**CERTIFICATE OF APPROPRIATENESS**

**Property:** 3618 Burlington Street, Lot 20, Tract 19, Block 6, Westmoreland Subdivision. The property includes a historic 5,880 square foot, one-story wood frame single-family residence situated on a 11,250 square foot corner lot.

**Proposal:** Alteration – Relocate a pair of non-original doors from the back wall to the north side wall (in place of existing non-original windows to be removed) and install new windows in their place. Construct an attached open deck around the northwest rear corner of the residence. Install a balcony for existing double doors on the second floor of the north side.

**WEST (REAR) ELEVATION**

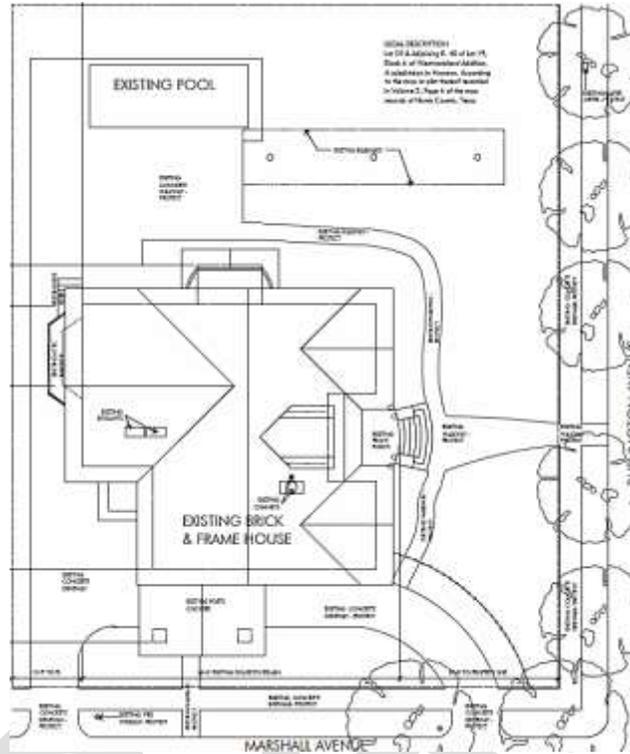
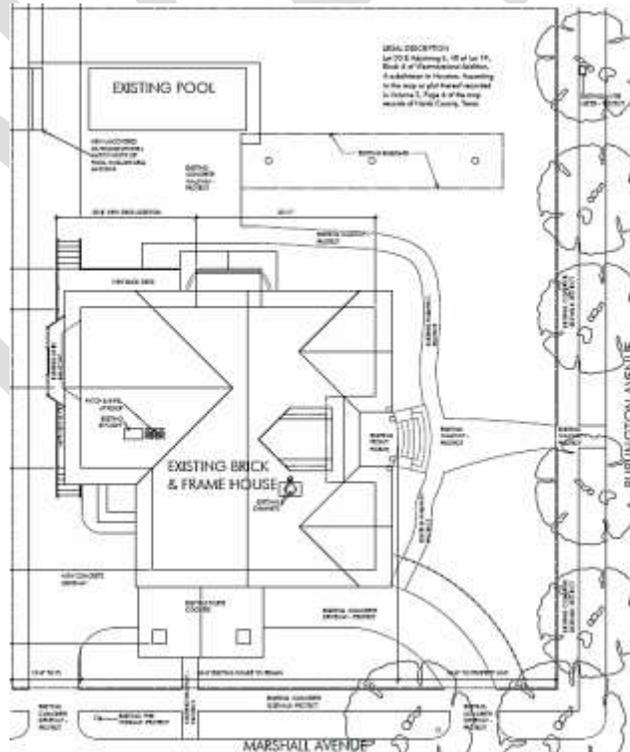
**Rear Elevation:** An existing wood deck measuring 14'-6" wide will remain and be expanded by 7'-7" to the north and 14'-9" to the south with wood steps at both ends. A section of wall containing cementitious shingles, double door and transom will be removed. Three windows with transoms will be installed with painted stucco to infill the opening.
